dsPIC30F5011/5013 Family Silicon Errata and Data Sheet Clarification

The dsPIC30F5011/5013 family devices that you have received conform functionally to the current Device Data Sheet (DS70116J), except for the anomalies described in this document.

Note: This document summarizes all silicon errata issues from all revisions of silicon, previous as well as current. Only the issues indicated in the last column of [Table 2](#) apply to the current silicon revision (**A5**).

FIGURE 1: dsPIC30F5011/5013 DATA EEPROM

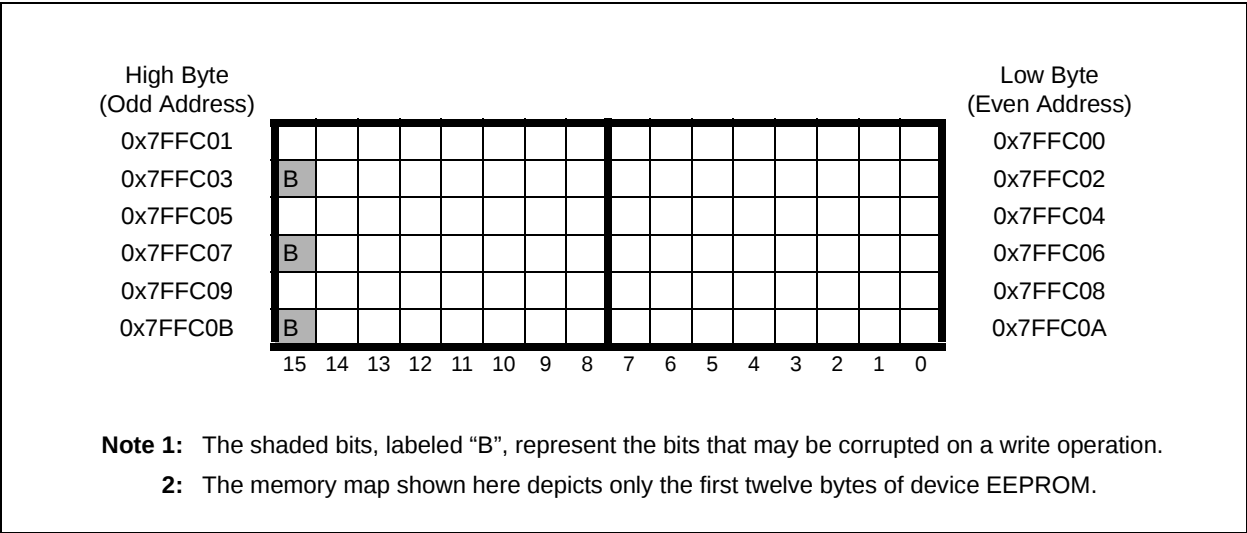
Figure 1 shows the first twelve bytes in data EEPROM and indicates the affected bits.
